Access Compliance Report

Public Rights-of-Way

(Curb Ramps)

Intersection ID: 49320	Main Street: TAVISTOCK_CT	Cross Street: HUNTERS_MOON_LN	Location: SE
ADA ID: F5F5DC0CA54B	Ramp Type: Perp	Initial Pass/Fail: Fail	Overall Compliance: No Severity Score: 13.75

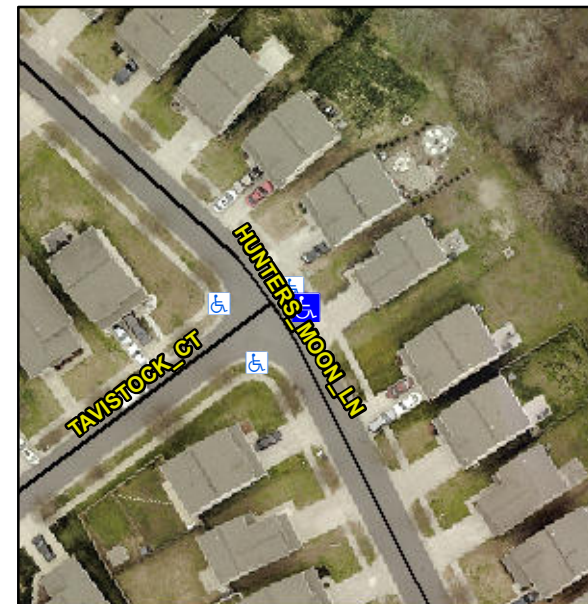
R304.2.2

Compliance	Description	Data	Compliance	Description	Data
N/A	Ramp Length (in)	69.0	No	Ramp Slope (%)	10.1
Yes	Ramp Width (in)	48.0	Yes	Ramp XSlope (%)	2.3
N/A	Flare Type LT	N/A	N/A	Flare Type RT	N/A
N/A	Flare Slope LT (%)	N/A	N/A	Flare Slope RT (%)	N/A
N/A	Flare Traversable LT?	N/A	N/A	Flare Traversable RT?	N/A
N/A	Landing Length (in)	N/A	N/A	DWS Provided?	N/A
N/A	Landing Width (in)	N/A	N/A	DWS Contrast?	N/A
N/A	Landing Slope (%)	N/A	N/A	DWS Length (in)	N/A
N/A	Landing X Slope (%)	N/A	N/A	DWS Full Width?	N/A
N/A	Landing Curb? (Y/N)	N/A	N/A	DWS Offset (in)	N/A
N/A	Shared Landing?	N/A			
N/A	Gutter Ponding?	N/A	N/A	Gutter Slope (%)	N/A
N/A	Gutter Lip Ht (in)	N/A	N/A	Gutter X Slope (%)	N/A
N/A	Painted X Walk1?	No	N/A	Painted X Walk2?	N/A
	X Walk 1 Direction	To SW		X Walk 2 Direction	N/A
N/A	X Walk 1 Width (in)	N/A	N/A	X Walk 2 Width (in)	N/A
	X Walk 1 Slope (%)	2.3		X Walk 2 Slope (%)	N/A
	X Walk 1 X Slope (%)	3.5		X Walk 2 X Slope (%)	N/A

Remove & Replace Entire Ramp.
